# DEVELOPMENT SERVICES

## PLANNING AND ZONING BOARD STAFF REPORT

314 NE 3<sup>rd</sup> Avenue

Meeting	File No.	Application Type
July 15, 2024	2024-081-SPF-SPR-LV4	Architectural Style
Applicant/Property Owner		Authorized Agent
Ocean Parker Delray, LLC		Jeffrey A. Costello, AICP, FRA-RA

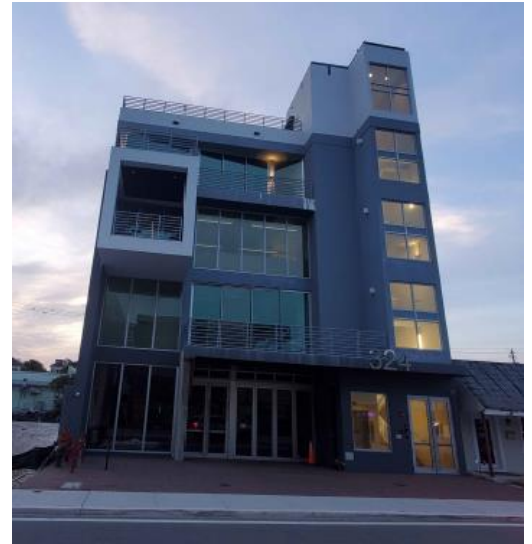
The proposed design claims to adhere to the Masonry Modern style but falls short in several critical areas. The extensive use of custom design metal surfaces to cover the walls, while considered more appropriate for other architectural styles such as contemporary, or high-tech architecture, is fundamentally at odds with the Masonry Modern style, which emphasizes solidity, simple geometries, and the use of stucco, stone, and wood details. The use of custom design metal surfaces on the walls is a significant deviation from the expected materials in Masonry Modern architecture. The guidelines emphasize stucco as the prevalent finish, with stone and wood details to add warmth and texture. The metal surfaces not only fail to provide the desired solidity and simplicity but also create a stark, post-industrial appearance that contrasts with the style's principles. More thoughtful integration of materials and decorative elements would enhance the building's visual appeal and alignment with the guidelines.

While the design adheres to the tripartite composition in theory, the execution is not ideal. The base lacks sufficient transparency and prominence, and the middle section, intended to be more solid, is compromised by the inappropriate metal surfaces, which disrupt the visual cohesion and simplicity typical of Masonry Modern. However, the top section does utilize the opportunities for usable exterior spaces and shading elements.

The design's approach to openings, featuring punched openings and recessed windows, is consistent with Masonry Modern principles. However, the placement and proportions of the windows lack coherence and visual harmony. The windows are not sufficiently recessed to produce the deep shadows characteristic of the style, and their simplistic geometry fails to add the necessary visual depth and interest.
